Limited building only review  
Permit holder responsible for  
full compliance with the code

12' X 14' ORGANIZER  
(ALPINE) 9/12 PITCH

Re: Structural Certification  
10', 12', & 16' Organizer Sheds

FLOOR FRAMING

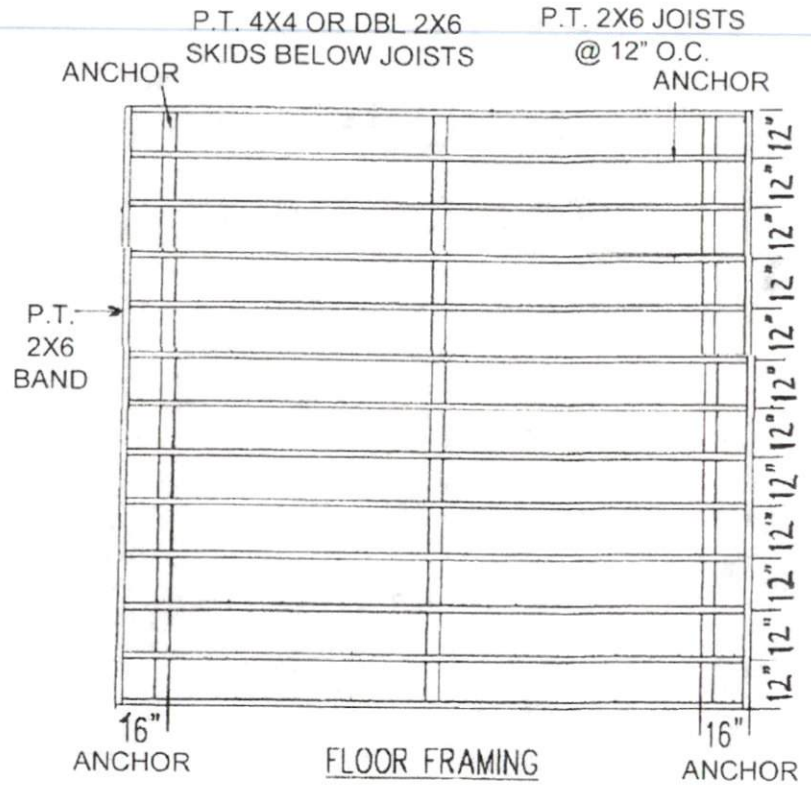
The floor framing consists of 2x6 joists at 16" on center supported on three (3) 4x4 "skids". Please be advised that the 2x6 floor joists can have a maximum of 10 1/2" cantilever beyond the 4x4 supports. Furthermore, please be advised that the 4x4 skids must be intermediately supported by piers at a maximum of 4' on center. Alternatively, if a double 2x6 beam is used for the skids, they must be supported at a maximum of 5' on center. The skids may bear on 8"x16" CMU piers which bear directly on the soil. The piers may be constructed with dry stacked concrete masonry units, with solid units top and bottom and hollow 8" concrete

masonry units for the remainder of the pier at a maximum height of 36". The floor framing should be tied down with 30" screw anchors and 1" metal strapping across the floor joists.

ROOF FRAMING

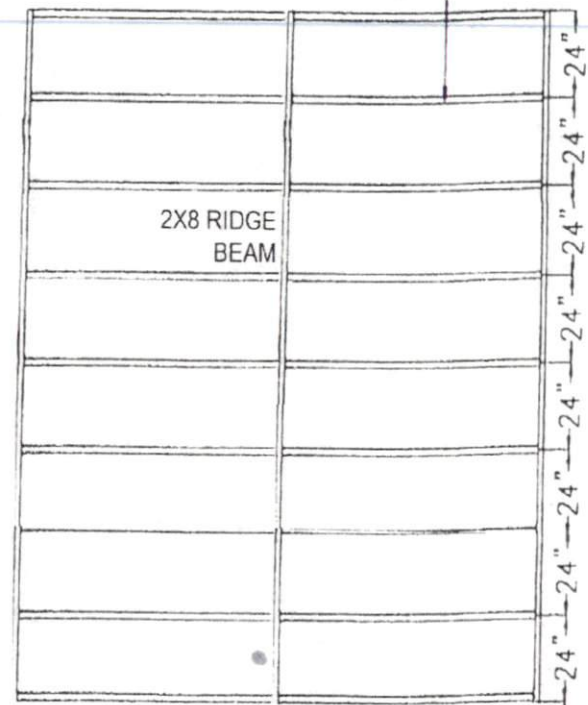
This variation consists of a 12' wide shed with a gable roof system. The roof consists of 2x6 rafters @ 2'-0" on center at a 5:12 or 9:12 pitch, and the walls are constructed with 2x4 studs at 16" on center. Please be advised that the rafters shall be cross-tied with 2x4 collar ties located at the 1/3 point extending downward from the ridge and spaced at 4'-0" on center. A 2x ridge board shall be provided for the connections of the opposing rafters at the ridge. The collar ties should be attached at each rafter with a minimum of (8) 10d nails
